Access Compliance Report

Public Rights-of-Way

(Curb Ramps)

Intersection ID: 16905	Main Street: BILTMORE_DR	Cross Street: SCOTLAND_AV	Location:	N
ADA ID: 96D7ECB7E88D	Ramp Type: BlendTrans2	Initial Pass/Fail: Pass	Overall Compliance: No	Severity Score: 0.25
Codes/Mitigation Info/Possible Solution		Field Measurements/Component Compliance

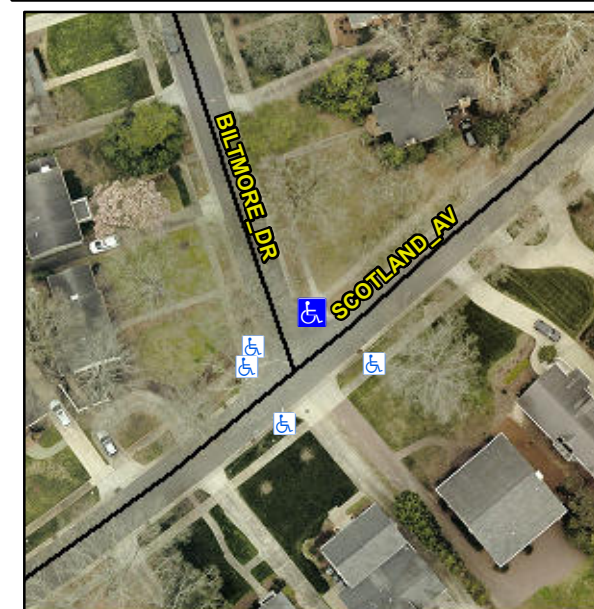
Not Found, R304.5.3, R305.2

Compliance	Description	Data	Compliance	Description	Data
N/A	Ramp Length (in)	135.0	Yes	BlendTrans Slope (%)	3.5
Yes	Ramp Width (in)	50.0	No	BlendTrans XSlope (%)	2.6
N/A	Flare Type LT	Sloped	N/A	Flare Type RT	Sloped
N/A	Flare Slope LT (%)	N/A	N/A	Flare Slope RT (%)	N/A
N/A	Flare Traversable LT?	No	N/A	Flare Traversable RT?	No
N/A	Landing Length (in)	N/A	Yes	DWS Provided?	Yes
N/A	Landing Width (in)	N/A	Yes	DWS Contrast?	Yes
N/A	Landing Slope (%)	N/A	Yes	DWS Length (in)	24.0
N/A	Landing X Slope (%)	N/A	Yes	DWS Full Width?	Yes
N/A	Landing Curb? (Y/N)	No	No	DWS Offset (in)	3.0
N/A	Shared Landing?	No			
Yes	Gutter Ponding?	No	Yes	Gutter Slope (%)	0.6
Yes	Gutter Lip Ht (in)	0.0	No	Gutter X Slope (%)	3.4
N/A	Painted X Walk1?	No	N/A	Painted X Walk2?	No
	X Walk 1 Direction	To SW		X Walk 2 Direction	To SE
	X Walk 1 Width (in)	N/A		X Walk 2 Width (in)	N/A
	X Walk 1 Slope (%)	0.7		X Walk 2 Slope (%)	2.0
	X Walk 1 X Slope (%)	3.5		X Walk 2 X Slope (%)	1.4

N/A	Ramp inside XWalk1?	N/A	N/A	Ramp inside XWalk2?	N/A
	Road Slope (%)	2.1		Clear Space?	Yes
	Road X Slope (%)	0.3	N/A	Clear Space to XWalk (in)	N/A
Yes	Any Obstructions?	No	Yes	Storm Grate/Utility Hazard?	No
	Obstruction Type			Storm Grate/Utility Type	
		N/A			N/A
			Yes	Surface Condition? (G/P)	Good
			No	Curb Slope (%)	12.7

Remove & Replace Curb Ramp With Two New Directional Ramps or Equivalent. Remove & Replace Gutter.
